CONTENTS

APPENDIX 14

14A ANSWERS TO QUESTIONS

FIGURE 14A.6-1  
 VESSEL PRESSURE VERSUS TIME - 4-INCH  
 ID TOP RUPTURE. LOFT TEST NUMBER  
 548, 100 PERCENT BREAK AREA

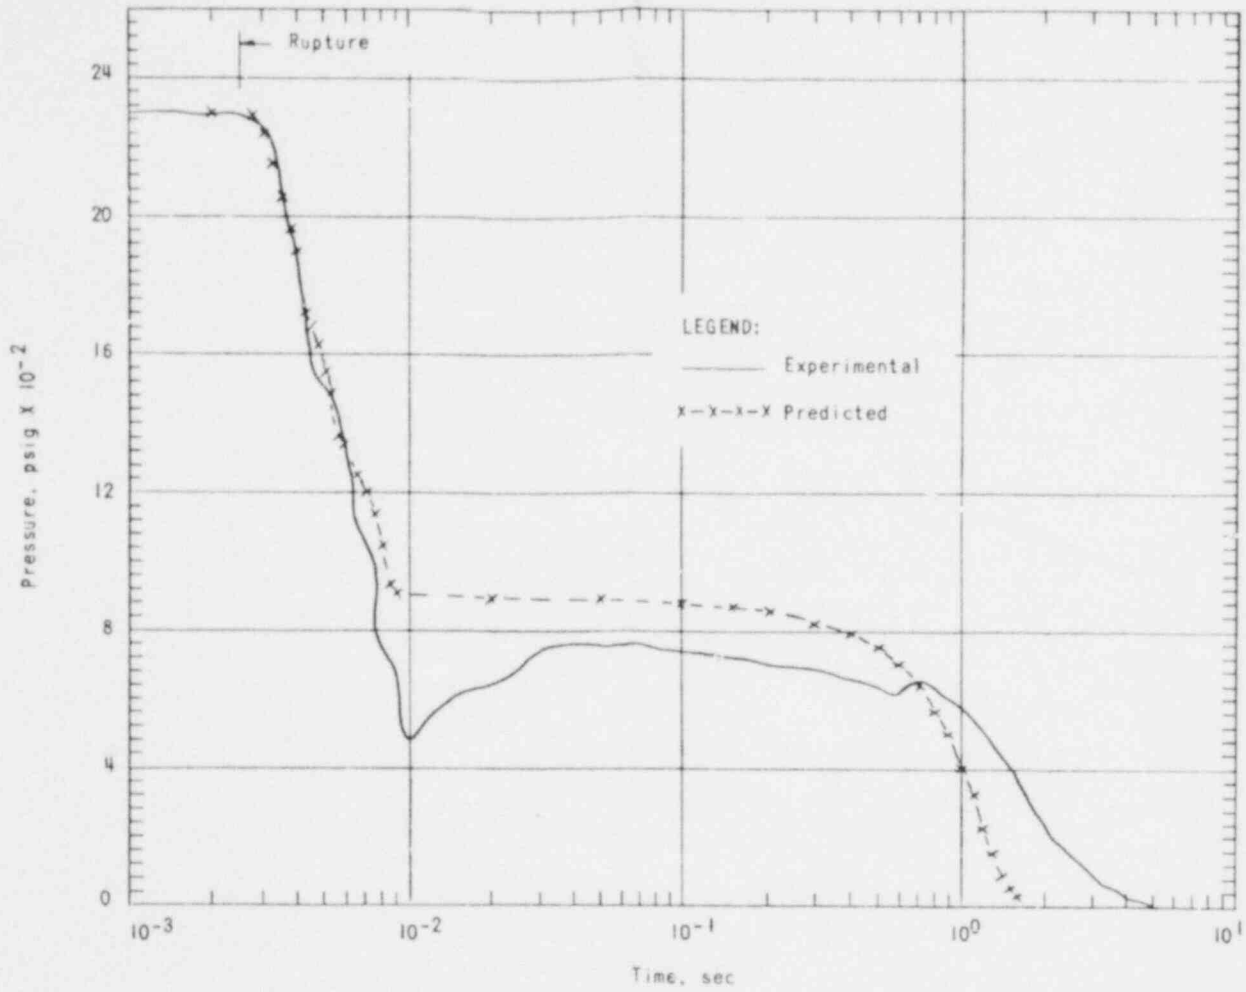
Provide an analysis of the loss-of-coolant accident for a spectrum of break sizes and locations, including those breaks in the emergency core cooling systems which also reduce the injection capability. Include curves of the pressure, water level, and fuel cladding temperature transients for each break size considered. Submit a chart showing the overlap and redundancy in the systems which cover various break sizes. Discuss the following:

- 14A.6.1 A detailed description of how the steam bubble velocity as a function of pressure was determined. Include a description of the physical process occurring in the reactor vessel during blowdown and discuss the limits of applicability of steady-state bubble rise data to blowdown analyses.
- 14A.6.2 A comparison of pressure and water level transients for the variable-bubble-velocity model and the constant-bubble-velocity model for a spectrum of break sizes. In addition, compare these with LOFT semiscale blowdown data with and without internals in place for various break sizes.
- 14A.6.3 How the design of the high pressure injection system is affected by the assumed bubble velocity model.

Figures 14A.6-1 and 14A.6-2 show the FLASH predictions of pressure versus time using the variable bubble velocity as compared with the measured data for the 100 percent break area and the 6.1 percent break area. Figure 14A.6-1 shows that, for the 100 percent break area, the FLASH code predicts depressurization to be complete in less than 2 sec as compared with 5 sec from the test data. This implies that the two-phase critical

FIGURE 14A.7-2  
CORE QUIET WATER HEIGHT FOR  
A 28-INCH ID, DOUBLE-ENDED,  
COLD-LEG PIPE RUPTURE

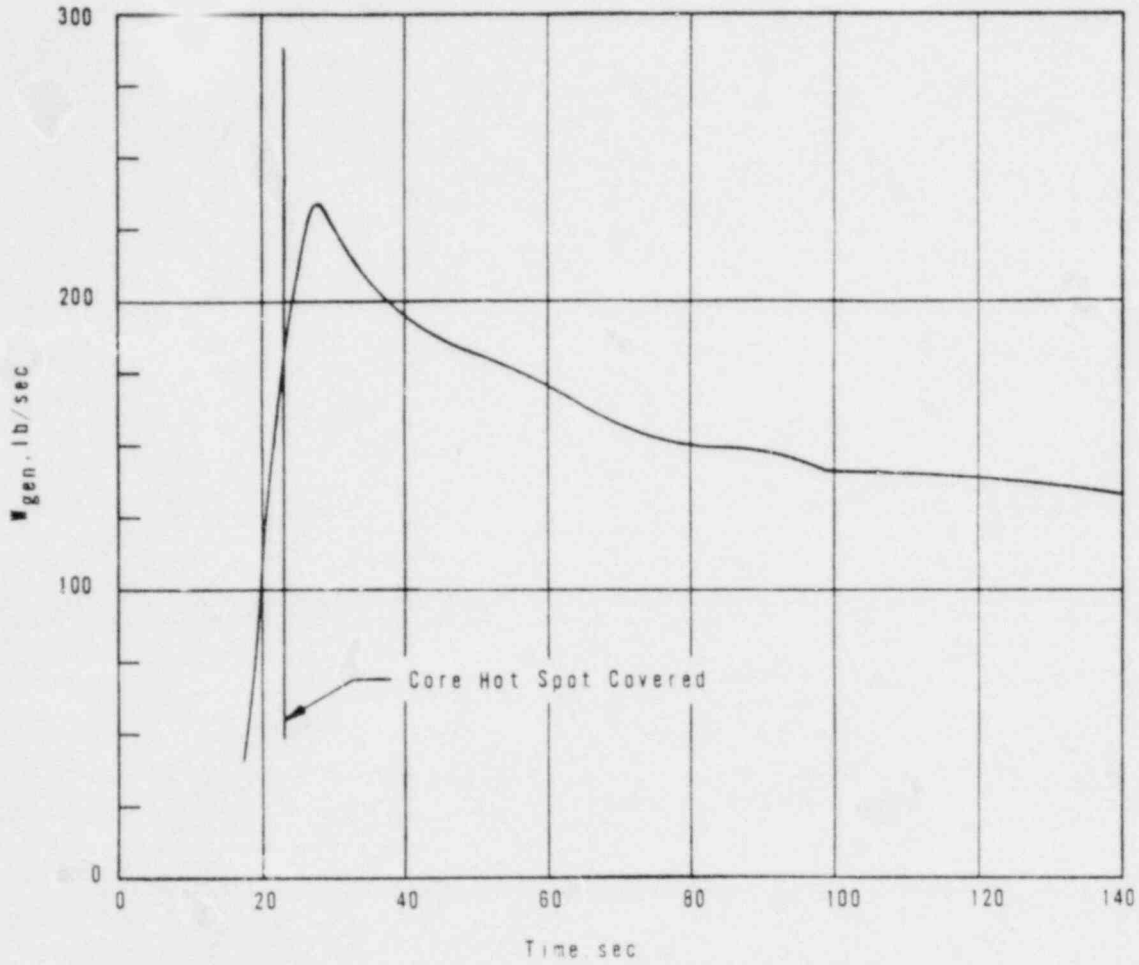
QUESTION  
14A.7

Figure 14A-7.2 shows the water height as a function of time after a double-ended inlet pipe rupture for the case where a water seal exists in the inlet piping. The steam flow through the vent valves provides for pressure equalization but the core flooding rate is restricted by the pressure buildup in the reactor vessel upper plenum. This curve is based upon the

FIGURE 14A.8-1  
 STEAM GENERATOR COMPARTMENT  
 DIFFERENTIAL PRESSURE  
 FOLLOWING PIPE RUPTURE

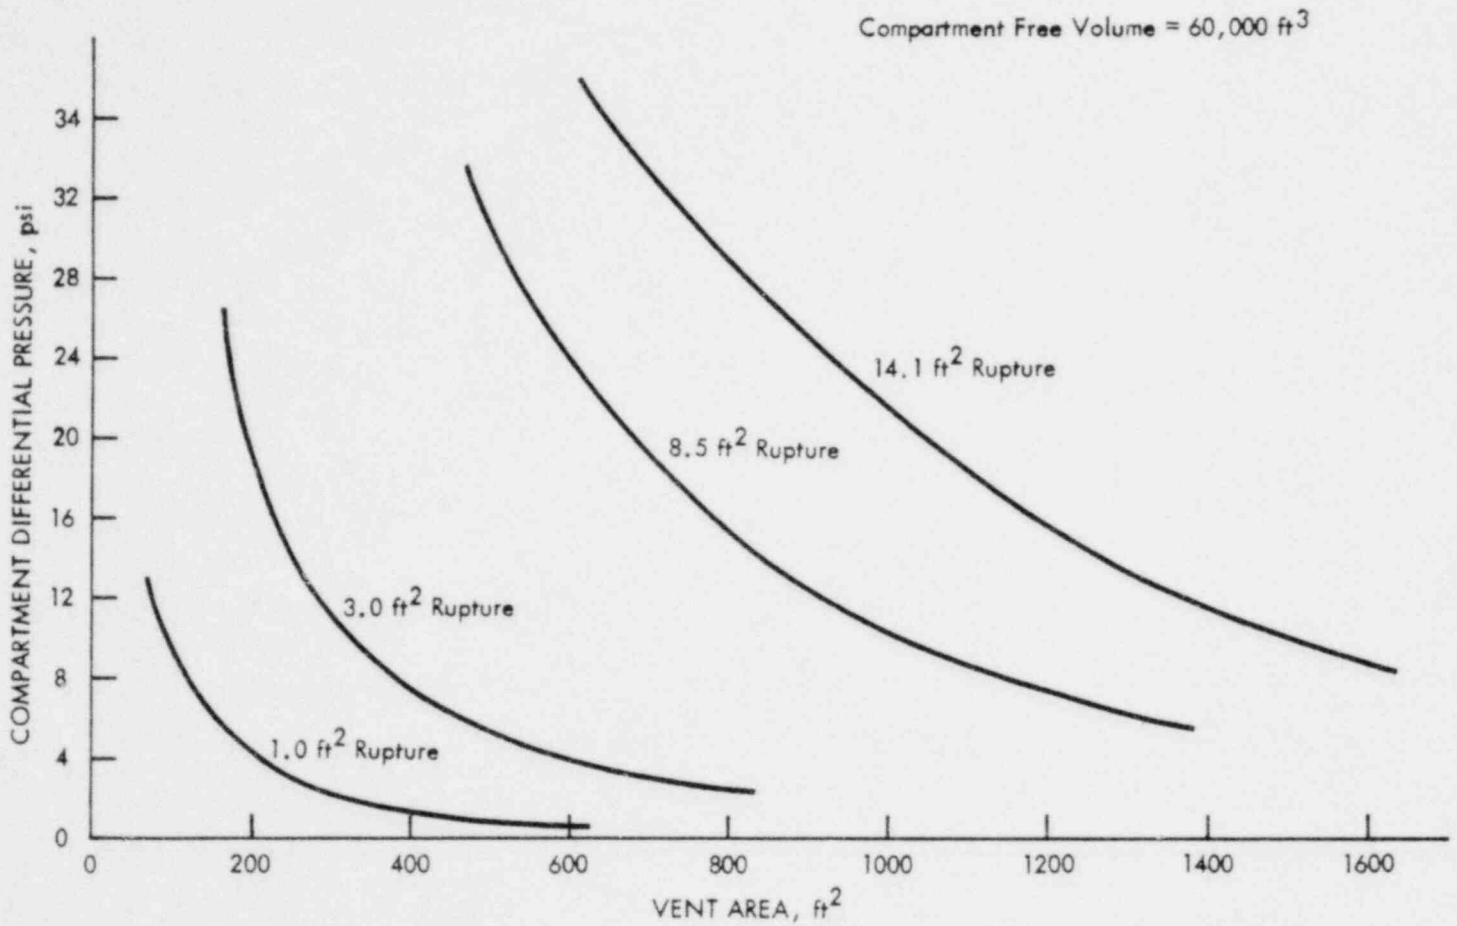
QUESTION 14A.8 Provide an analysis of local pressure forces imposed by primary coolant piping breaks within the primary cavity.

14A.8.3 The results for the case of the steam generator compartment are shown in Figure 14A.8-1. The final design will include sufficient vent area to be compatible with the structural strength of the walls for the 14.1 ft<sup>2</sup> case.

FIGURE 14A.11-1  
 THYROID DOSE AT THE SITE BOUNDARY  
 AS A FUNCTION OF  $\lambda_L$  AND  $F_s$

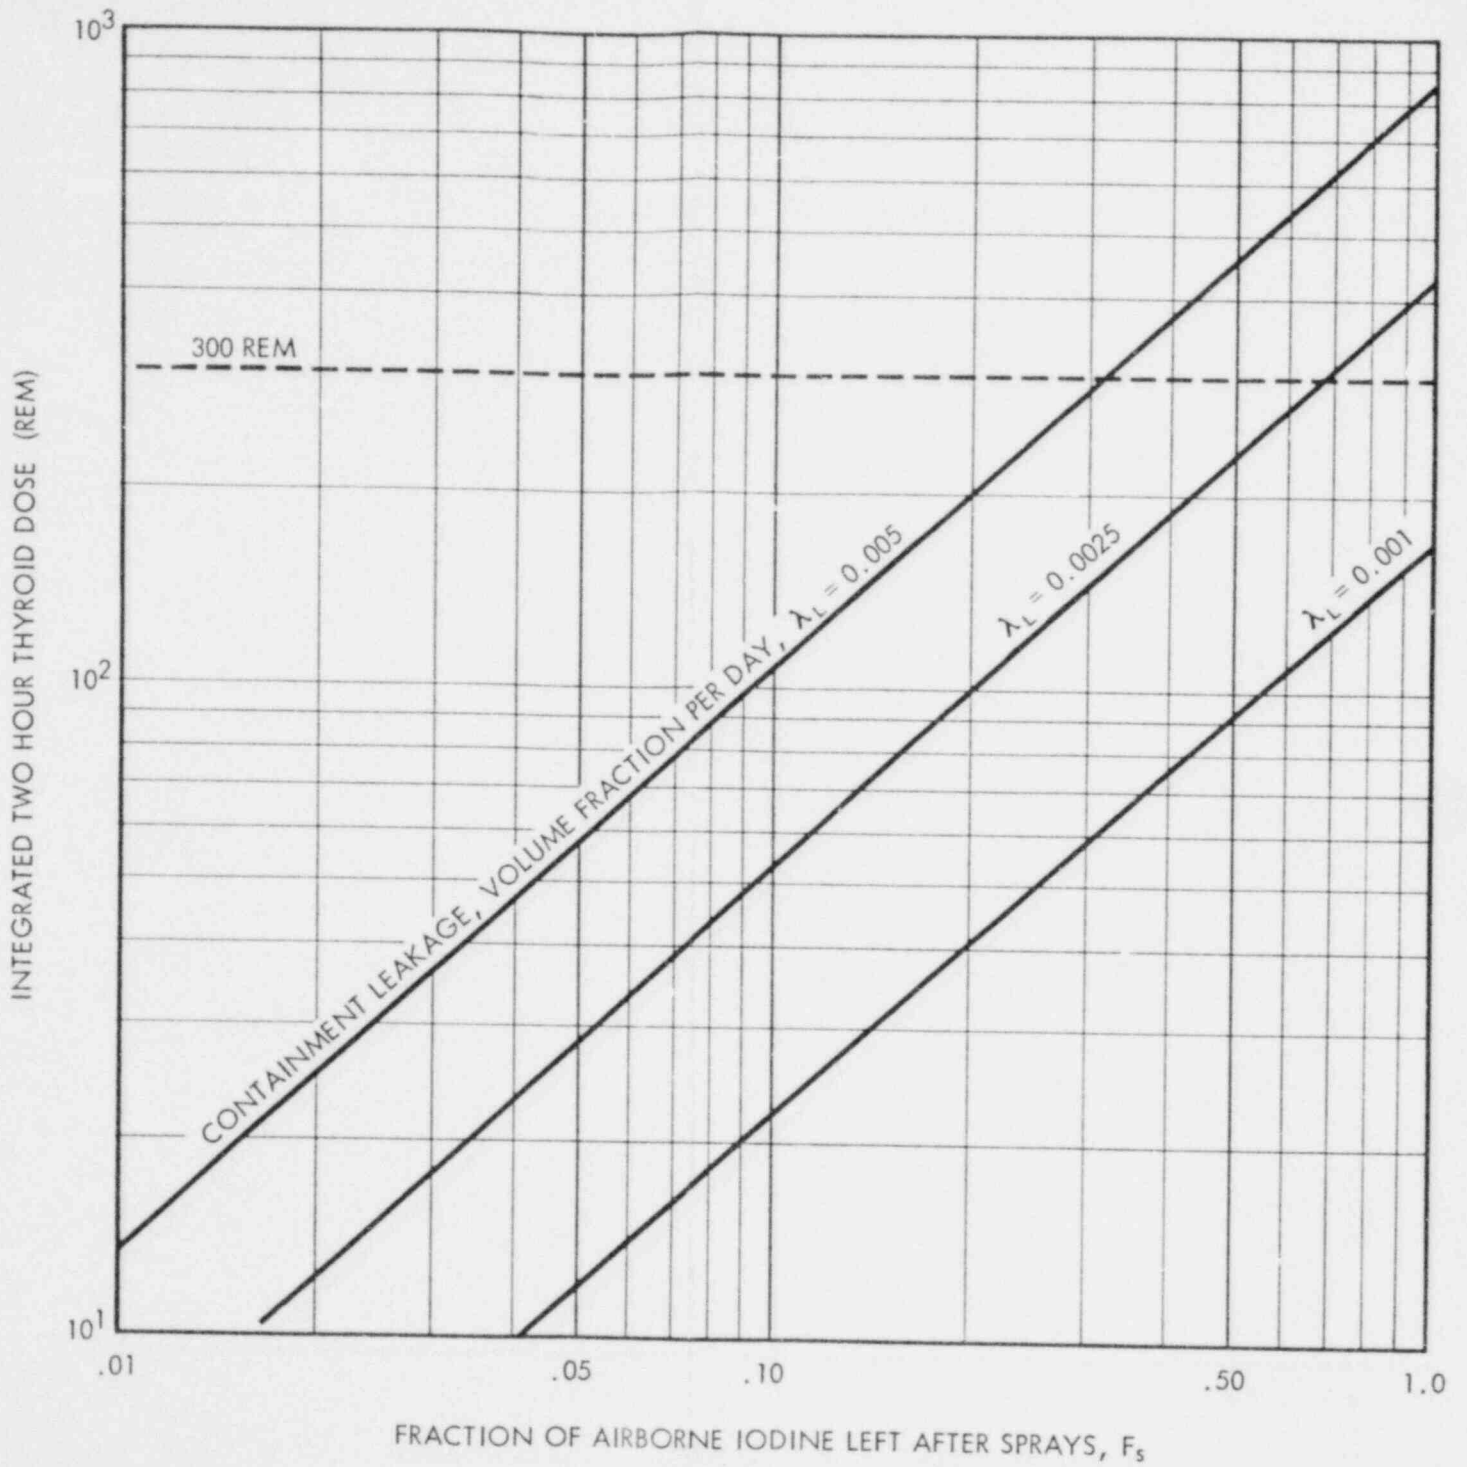
Provide calculations of the environmental effects resulting from an accident which released TID-14844 fission product fractions to the containment but in which 5% of the core iodine inventory is considered to be methyl iodide and that it is all released to the containment atmosphere (that is, 20% of the iodine in the containment atmosphere is in a nonremovable form). Also, a volumetric rather than a virtual source should be used for the release with a shape factor of one-half. Calculate the doses with and without thiosulfate spray.

Figure 14A.11-1 presents doses to the thyroid as a function of the iodine fraction left in the containment air after sprays,  $F_s$ , and the containment leakage rate,  $\lambda_L$ . The iodine time removal constant,  $F_s$ , is assumed to be  $25.3 \text{ Hr}^{-1}$ , as discussed in section 14.3.10 of the PSAR.

It may be observed from this figure that if 20% of iodine remain airborne after thiosulfate sprays (corresponding  $F_s = 0.2$ ) and is available for leakage then the thyroid dose at the site boundary will be 41, 100, and 200 rem if the containment building leakage is 0.1, 0.25, and 0.5% volumes per day, respectively. It can be also observed that if only 50% of airborne iodine is removed (corresponding to  $F = 0.5$ ) then the building leakage rates of 0.1% ( $\lambda_L = 0.001$ ) and 0.25% ( $\lambda_L = 0.0025$ ) will not result in doses in excess of the AEC guideline values. If no airborne iodine is removed from containment atmosphere, the dose to the thyroid at the site boundary would be 170 rem with a 0.1% leakage rate and 430 rem with a 0.25% leakage rate.

FIGURE 14A.18-1  
INTEGRATED THYROID  
DOSE 0-30 DAY

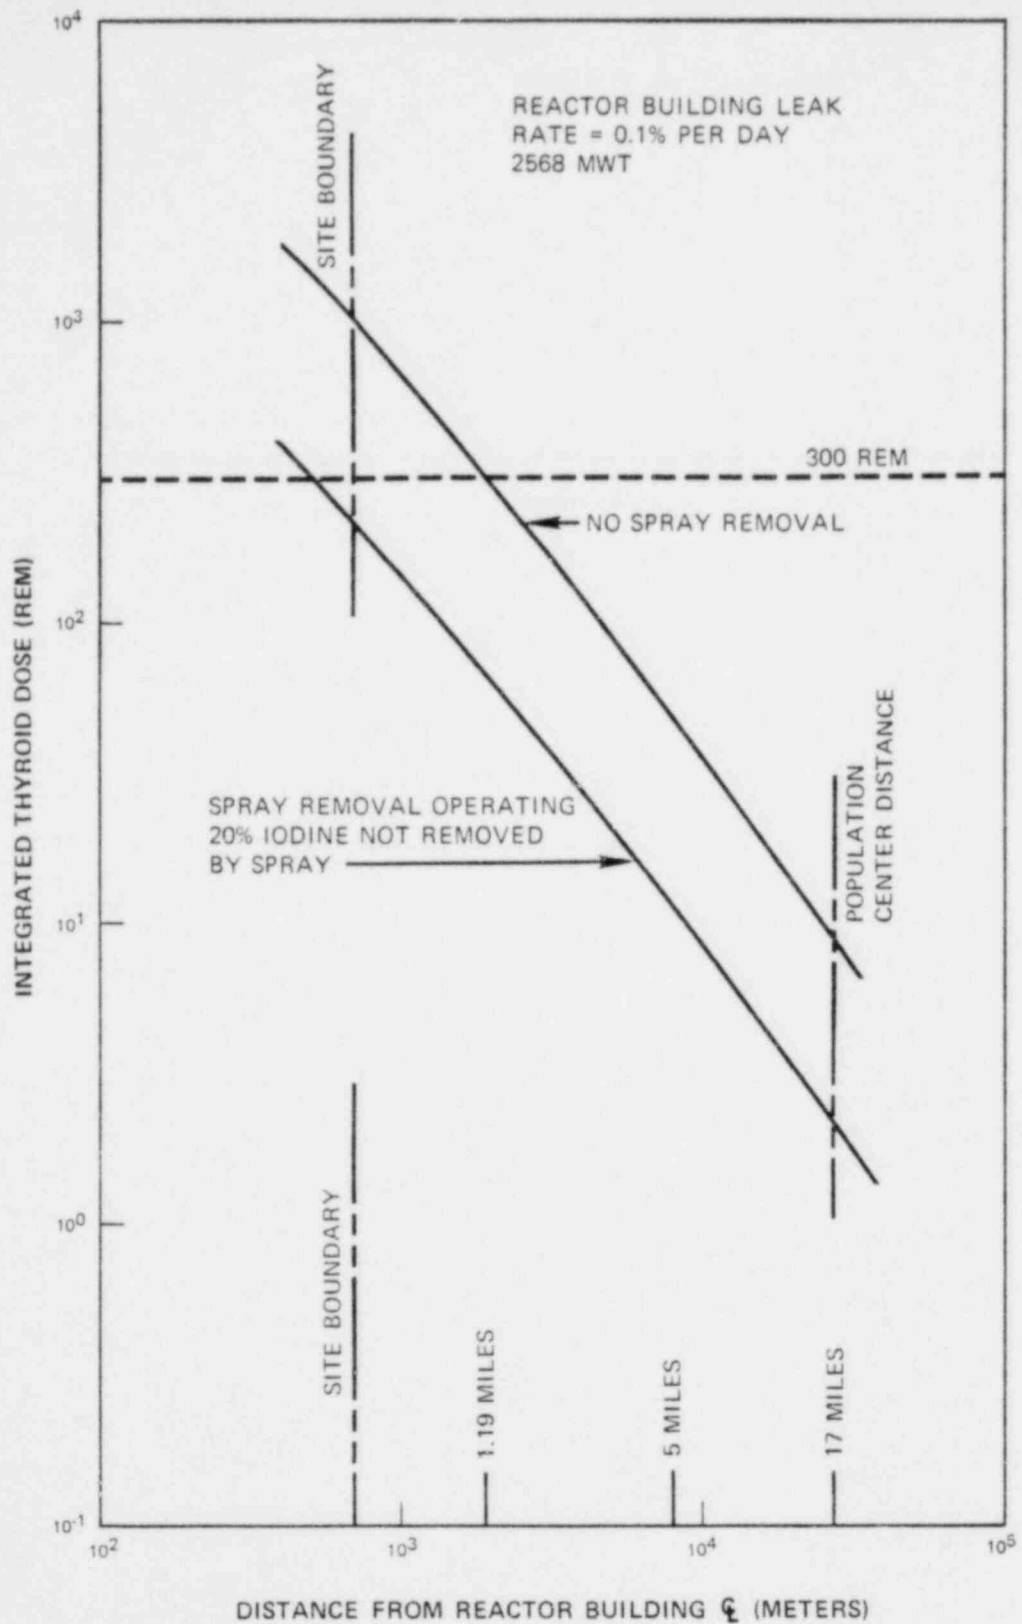
QUESTION 14A.18 (DRL 2.5) Specify the distance to the low population zone as it is defined in 10 CFR Part 100, Section 100.3 (b).

Results of these analyses show that under the criteria of 10 CFR 100.11, the low population boundary may be set at 1.19 miles from the site (no credit for spray). A comparison of the two cases analyzed is shown on Figure 14A.18-1.

FIGURE 14A.19-1  
 THYROID DOSE AT THE SITE BOUNDARY  
 AS A FUNCTION OF  $F_S$  AND METEOROLOGY

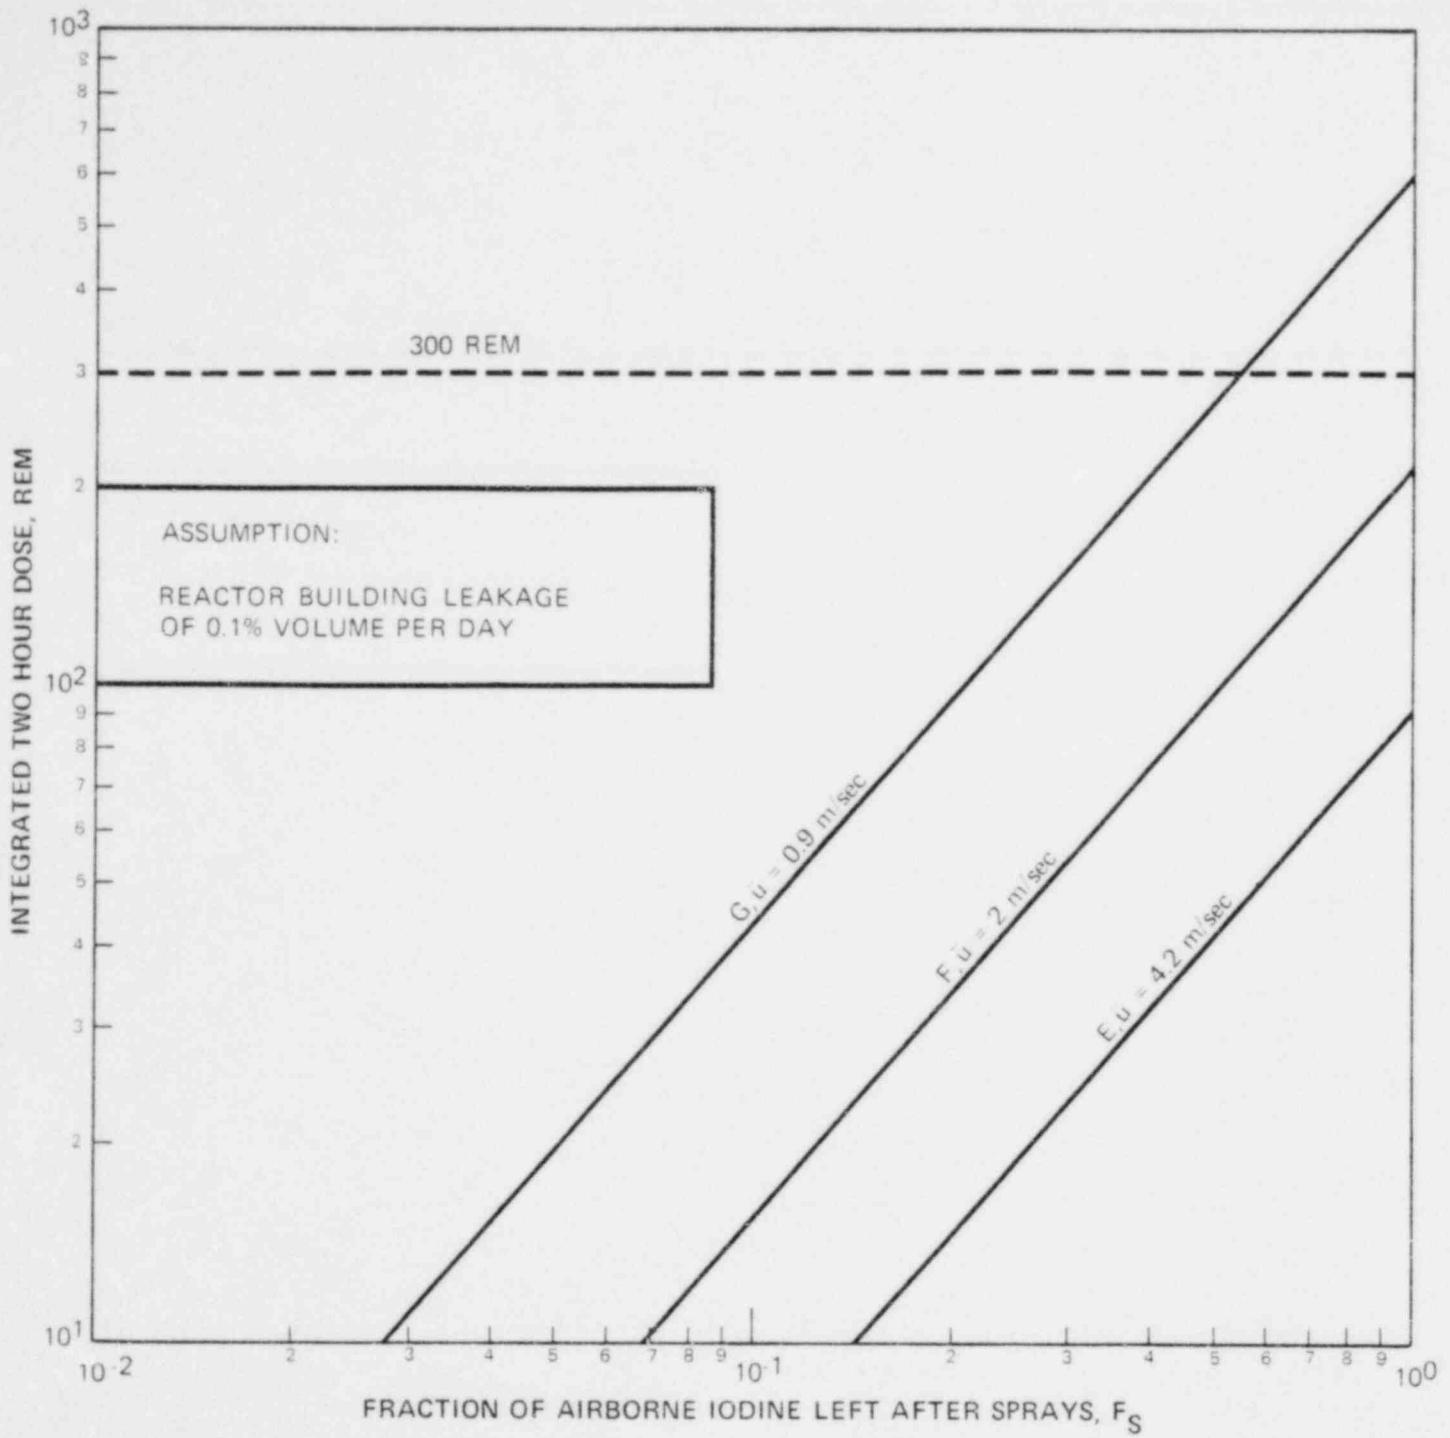
QUESTION 14A.19 (DRL 2.6) Based on data presented in the PSAR, it appears that the Rancho Seco site is subjected to a high frequency of inversion conditions with low transport winds. Data presented show a computed frequency of about 25% extremely stable conditions with an average wind speed of 0.9 meters per second; it would appear appropriately conservative to use this condition for calculating the 2 hour off-site doses. Please provide the environmental consequences of hypothetical accidents using this basis.

ANSWER Doses to the thyroid at the site boundary, following the Maximum Hypothetical Accident, computed for stability class G and a wind speed of 0.9 m/sec., are shown in Figure 14A.19-1. The values of  $\sigma_y$  for class G were obtained from Figure 21 of Appendix 2A. For comparison purposes, doses under class F (wind speed 2.0 m/sec) and class E (4.2 m/sec) are also shown. The doses are plotted as a function of the fraction of the released iodine remaining airborne in the Reactor Building after chemical additive sprays and are based on 0.1% per day leakage.
